Subject: Virgil C. Summer Nuclear Station
Docket No. 50/395
Operating License No. NPF-12
Reactor Coolant System Flow

South Carolina Electric and Gas Company hereby requests a revision to the Virgil C. Summer Nuclear Station Technical Specifications. This revision involves changes to Technical Specifications concerning the measurement uncertainty for the Reactor Coolant System (RCS) flow rate and defines allowable power levels for an RCS flow rate less than 100% of Thermal Design flow.

Figure 3.2-3 RCS FLOW RATE VERSUS R

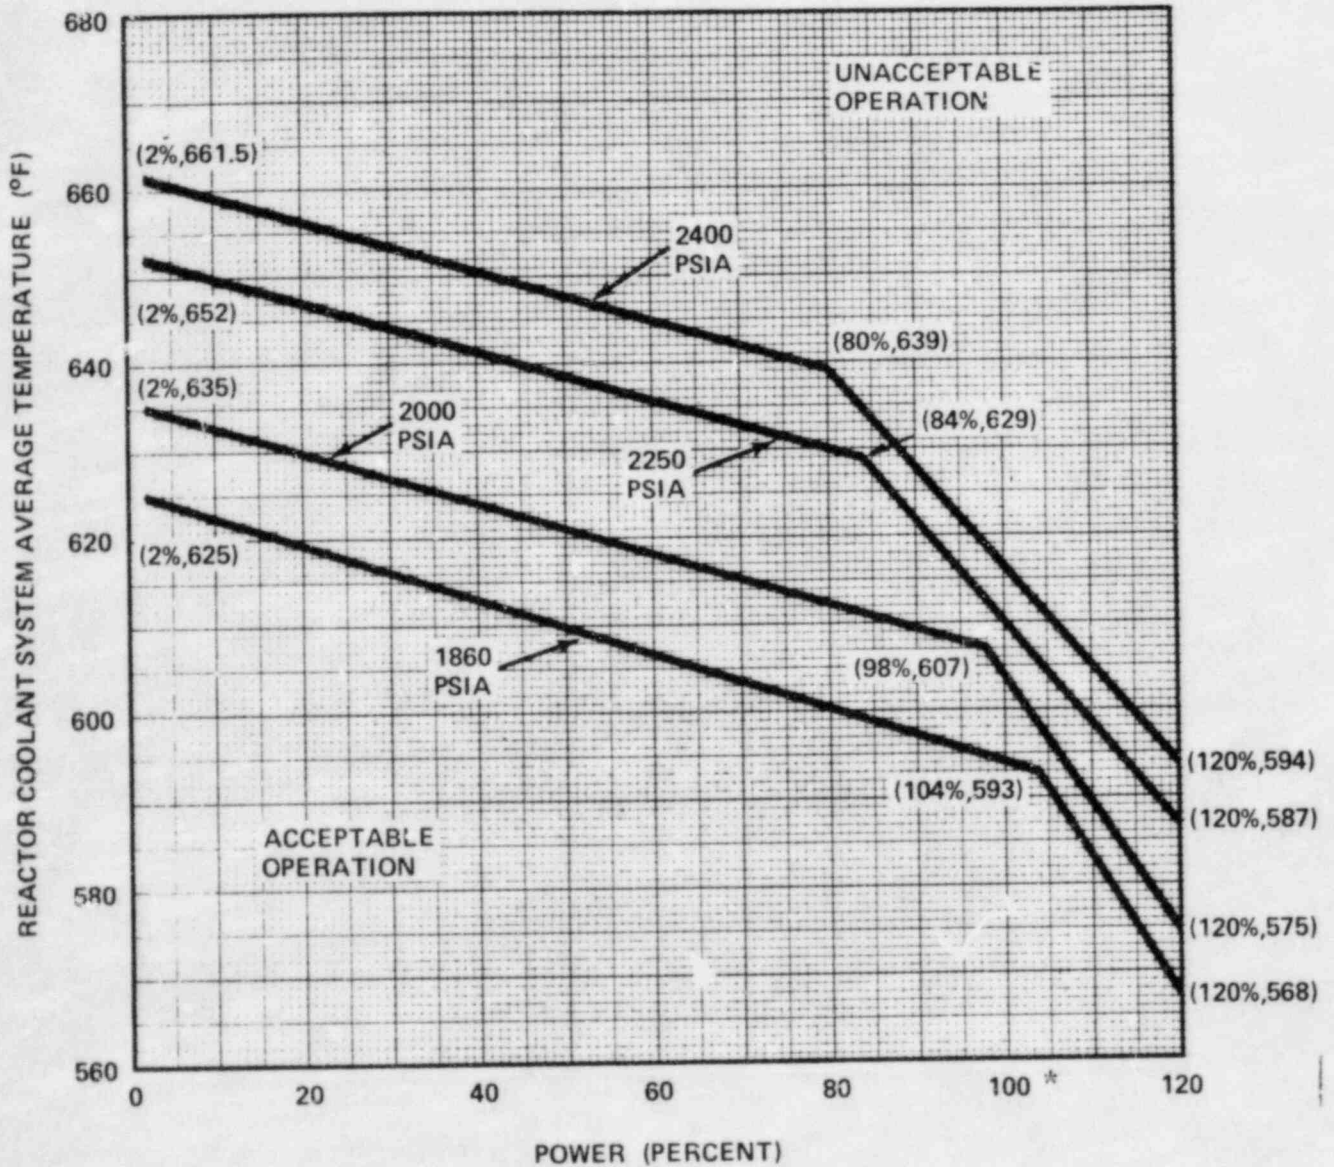
d. $F_{\Delta H}^N$ = Measured values of $F_{\Delta H}^N$ obtained by using the movable incore detectors to obtain a power distribution map. The measured values of $F_{\Delta H}^N$ shall be used to calculate R since Figure 3.2-3 includes measurement uncertainties of ~~3.5%~~ 2.0% for flow and 4% for incore measurement of $F_{\Delta H}^N$, and

NOTE: When operating in Region III, the restricted power levels shall be considered to be 100% of Rated Thermal Power (RTP) for Figure 2.1-1.

Current Technical Specification 3.2.3, Figure 3.2-3 limits operation to less than 5% of Rated Thermal Power (RTP) should measured RCS Flow be less than the TD flow used in the plant safety analyses. This Technical Specification does not recognize the possibility of a long term reduction in flow, nor the various trade-offs allowed by the relationships between flow, departure from nucleate boiling (DNB), and core power.

Based on a conservative assumption that the measured RCS flow will be no lower than 95% of TD flow, it is requested that a region of acceptable operation be added to Figure 3.2.3 for:

Considering the relationship given by Equation 3, it is recommended that the maximum power level for this region be reduced by 2% for each 1% reduction in measured flow below TD flow. This conservative restriction of core power is the equivalent of an RCS flow increase ranging from approximately 2.6% - 13.0% in terms of DNB margin for flow deficits up to 5%. Operation of the plant in this region within the specified power restriction does not result in increased T_{avg} , thus there is no temperature impact on the DNB margin.

The proposed change to Figure 3.2-3 to account for a reduction in measurement uncertainties (3.5% to 2.0%) for RCS flow has no effect on the Thermal Design flow. The Thermal Design flow which is utilized in the various safety analyses remains unchanged. In regard to the change which defines allowable power levels for an RCS flow rate less than 100% of Thermal Design flow, thermal-hydraulic sensitivity studies have shown that this power/flow tradeoff is conservative with respect to DNB margin.

FIGURE 1

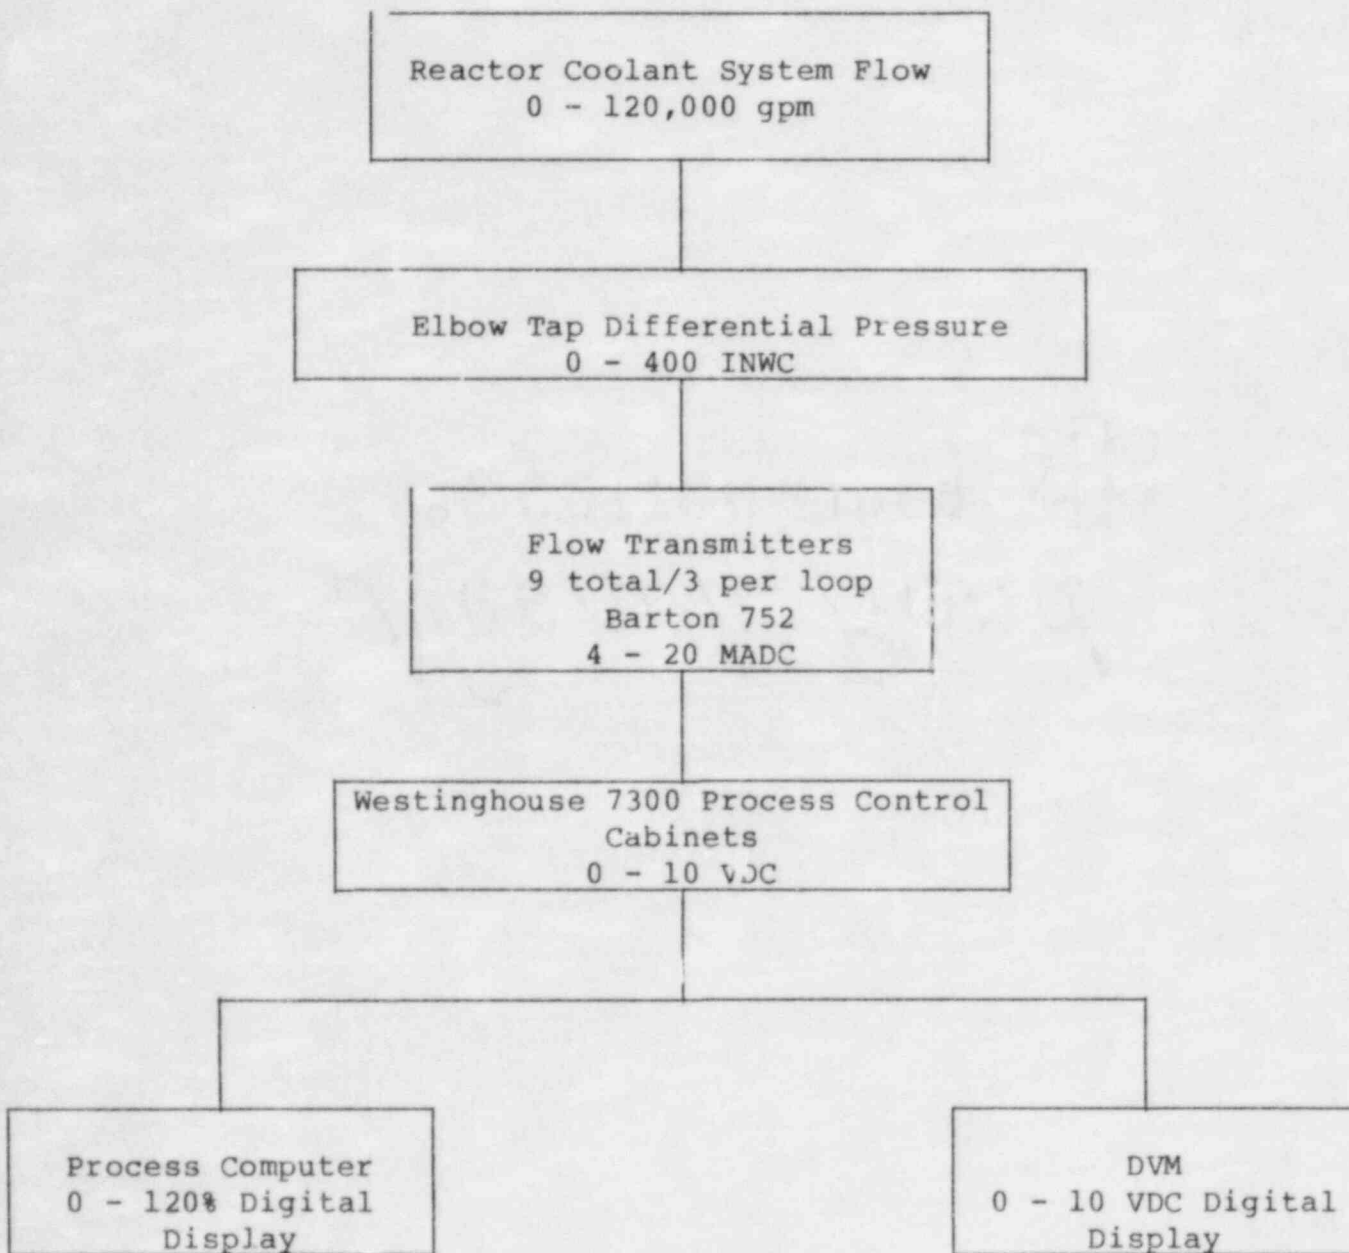
the elbow tap flow indication is depicted in Figure 1. Table 2 provides the list of components involved in the precision calorimetric flow calculations. The overall loop flow measurement uncertainty is the statistical summation of individual uncertainties (accounting for interactive effects where necessary) and appears at the bottom of Table 2
